DRAFT REPORT

3rd meeting of GRRF Informal Working Group on Automatically Commanded Steering Function

Dates: 02.-03. September 2015

6.2.2.16. FU1 (lane keeping test)

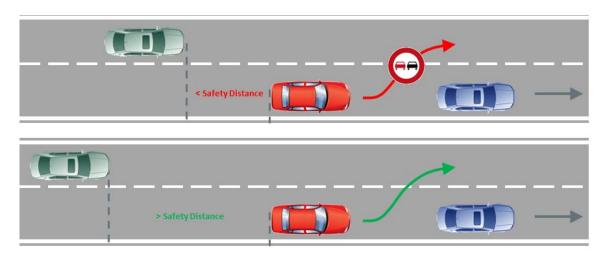
UK: system should also work without lead vehicle

D: main reason was to cover also Traffic Jam Assist (TJA) which may need a lead vehicle

EC: maybe different systems need different tests

UK: propose to concentrate first on CAT E

D: for CAT E no lead vehicle should be necessary

OICA: There may be CAT E systems only up to 40 km/h for traffic jam

D: In a traffic jam with max. 40 km/h a lane change makes no sense

Debate, whether the blue vehicle shall accelerate or change the lane, without result

Homework: OICA to define a new proposal for FU1-Test (CAT E)
